04V-114 ① of ②

SUBJECT: Campaign #90 – P-Series LP Tank Bracket

INSTRUCTIONS TO PERFORM CAMPAIGN #90 Addition of LP Gas Tank Mounting Cradle Brackets

ISSUE

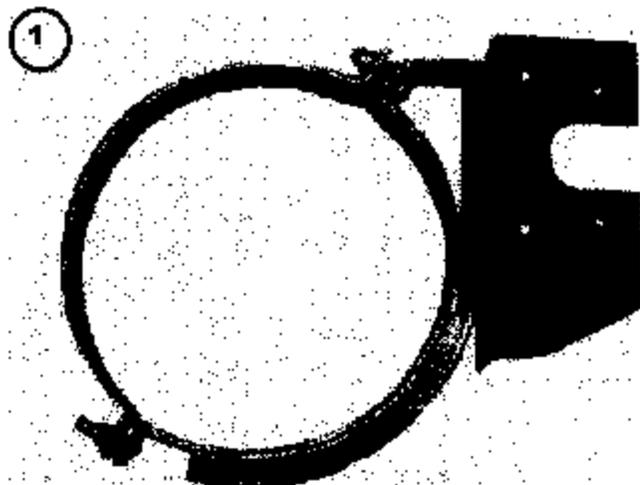
On affected vehicles, the weld joint on the Manchester/Brunner LP gas tank mounting fins may develop cracks due to road stress and cause a leak in the tank which could result in fire or explosion.

The basic procedure involves removing the LP gas tank, inspecting it for leaks and reinstalling it with new mounting cradle assemblies (photo 1).
